STAFF REPORT
KETCHUM PLANNING AND ZONING COMMISSION
REGULAR MEETING OF FEBRUARY 18, 2026

PROJECT: Lift View Townhomes

FILE NUMBER: P25-038 & P25-041

APPLICATION TYPE: Design Review and Townhouse Subdivision Preliminary Plat

LIFT VIEW TOWNHOMES
310 GEORGIA RD
LEVEL 1 FLOOR PLAN
KETCHUM
IDAHO

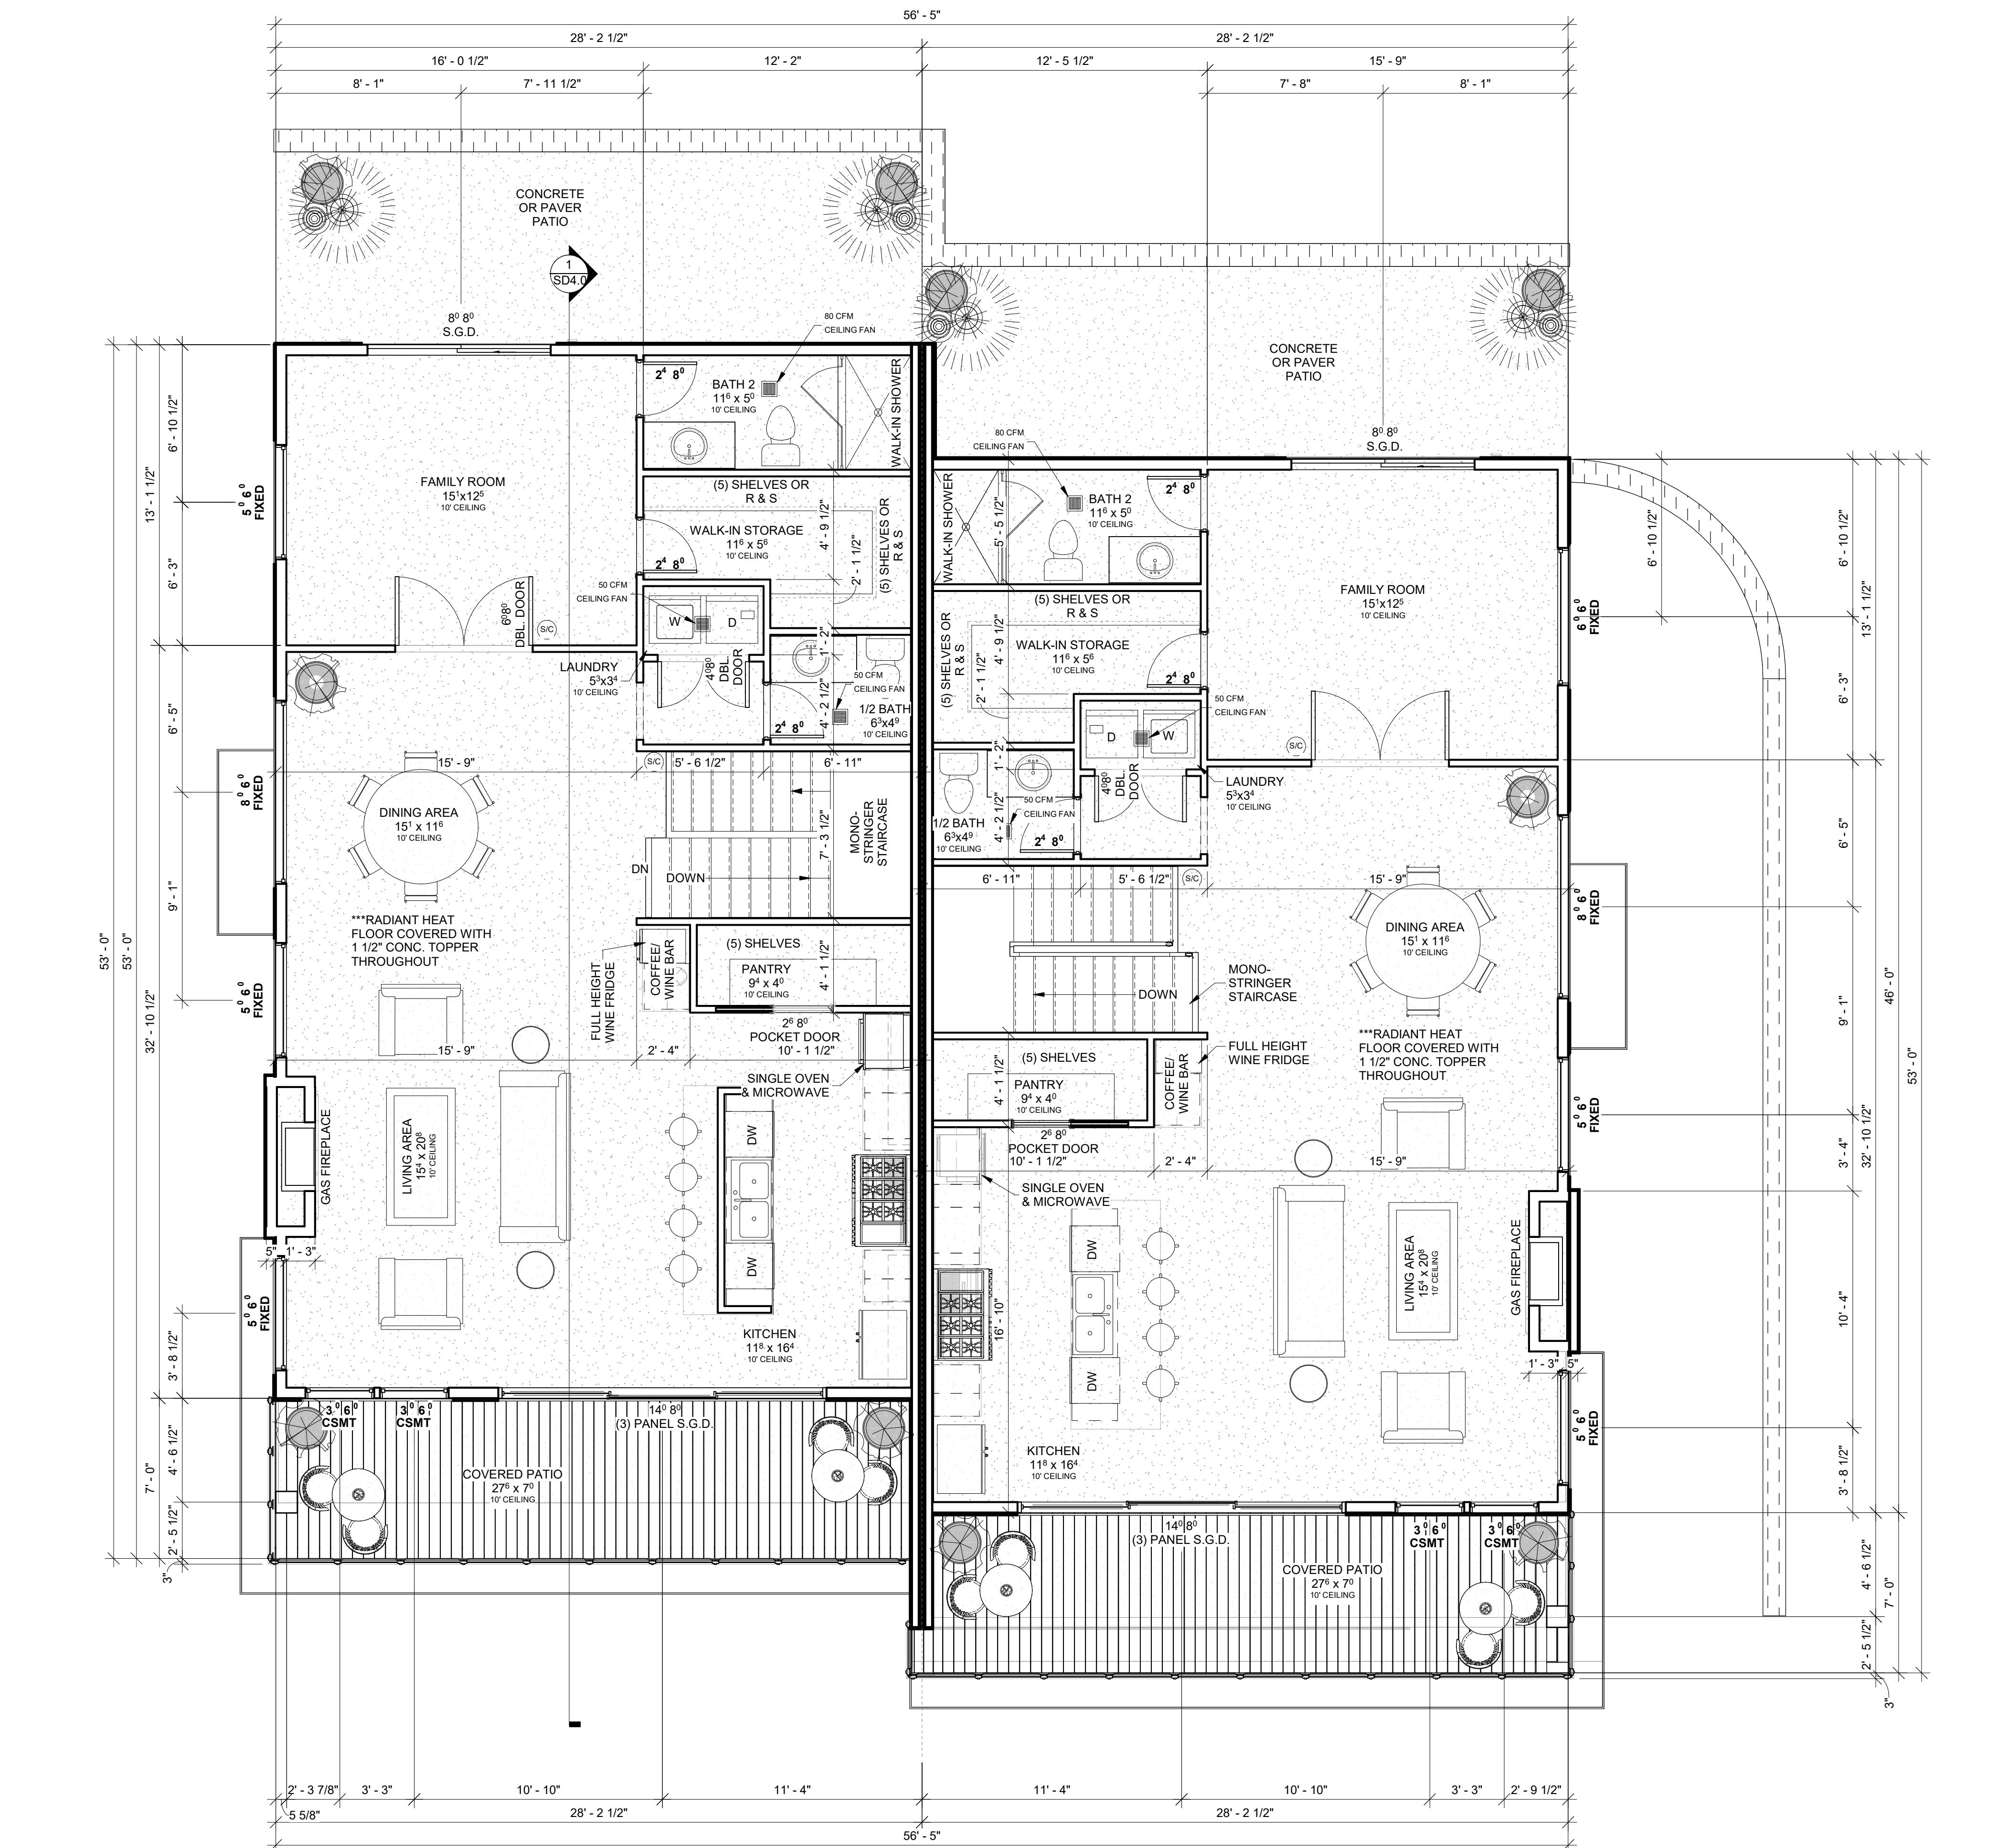
| 17.96.060.F.7 – Architectural | Conformance |
|--|-------------|
| Finding: No satellite receivers are proposed for the project. As shown on Sheet A2.0, the garage contains storage space to accommodate garbage bins. The garbage storage area will be contained with the enclosed garage and fully screened from public view. | |

FRONT ELEVATION

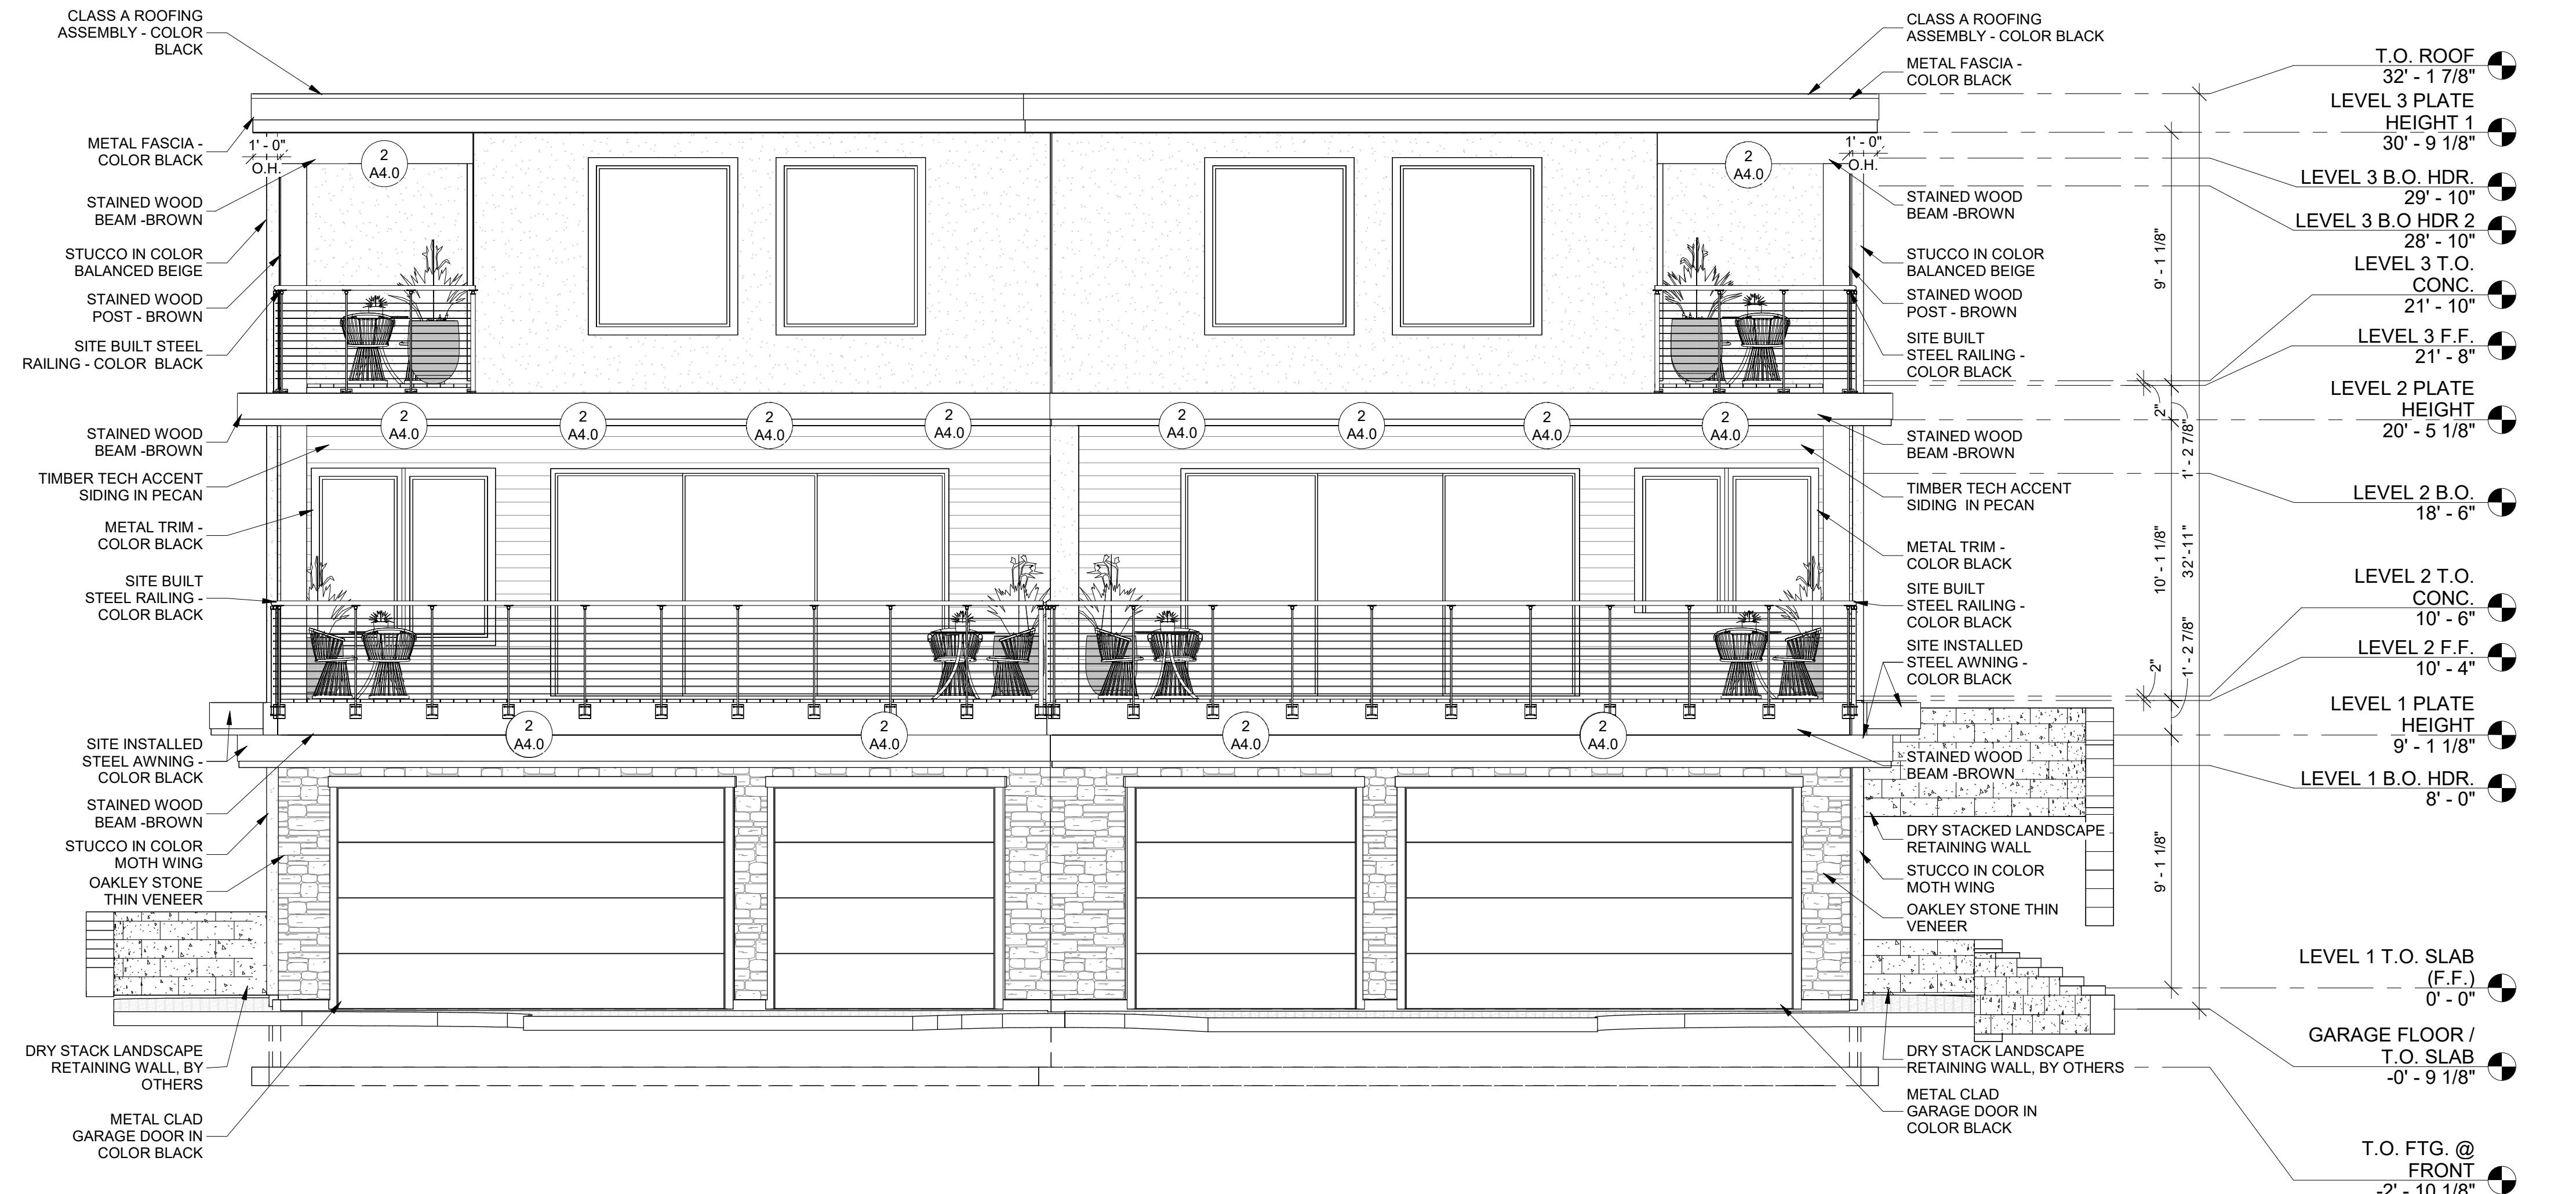
Pursuant to KMC §17.96.060.F6, buildings shall be oriented toward their primary street frontage. Staff does not believe the proposed design meets this standard because the street facing ground level elevation is dominated by garages doors while the primary entrances to both units are located on the sides of the structure and set far back on the side walls and are barely visible from the street. The applicant team revised the initial design to include steel awnings over the front entrances to better identify the entryways, however, the entrances remain oriented to the sides of the property and not the street frontage. By distinguishing the front-door entrances compared to the garage entrance creates a more active frontage that is more compatible with the orientation of homes in the surrounding neighborhood. Staff believes that by modifying the ground-floor design to reduce the

dominance of garage door openings and distinguishing the front-door entrances would help add visual interest and relief to the front façade at the ground floor. Staff requests the Commission to review the proposal and provide feedback on whether this standard is sufficiently met.

LIFT VIEW TOWNHOMES
310 GEORGIA RD
ROOF PLAN
IDAHO
KETCHUM

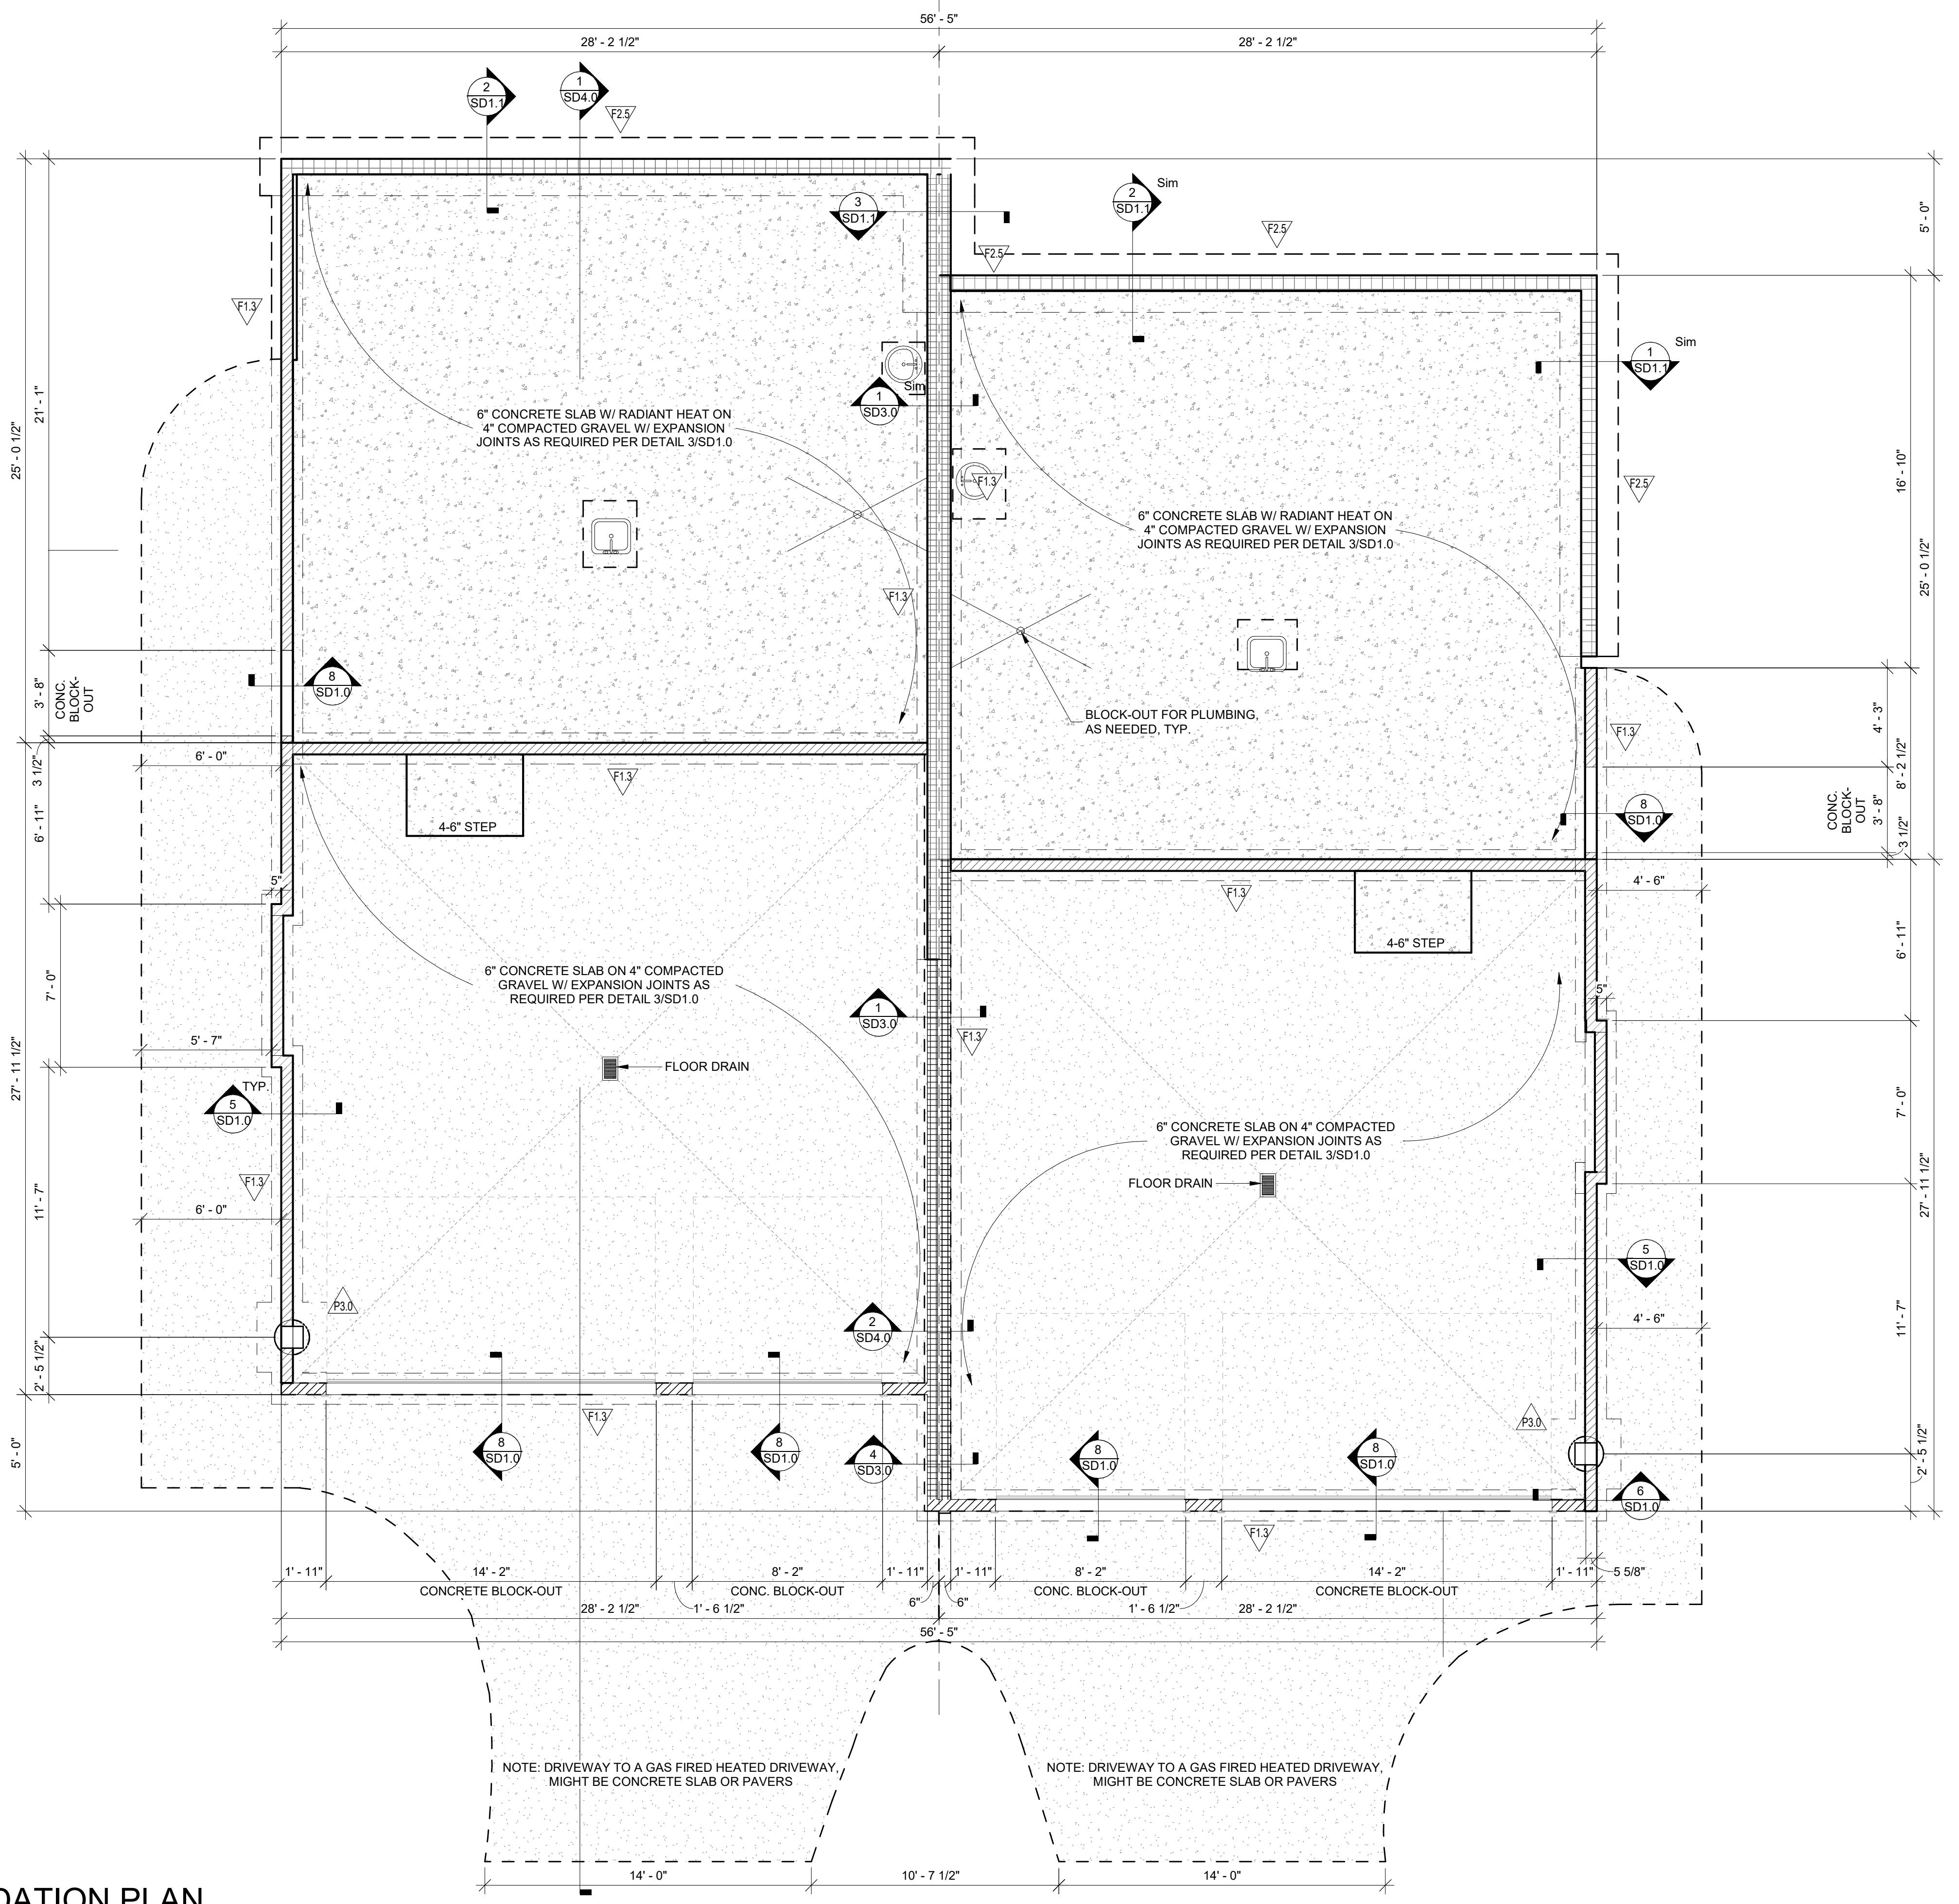
| 17.96.060.F.8 – Architectural | Conformance |
|---|-------------|
| Finding: The roof plan provided on Sheet A5.0 shows that the flat roof will be sloped to drain and gutters and downspouts will be installed at all roof eaves to manage roof drainage. The front entryways feature flat metal awnings which will provide weather protection for the residents. | |
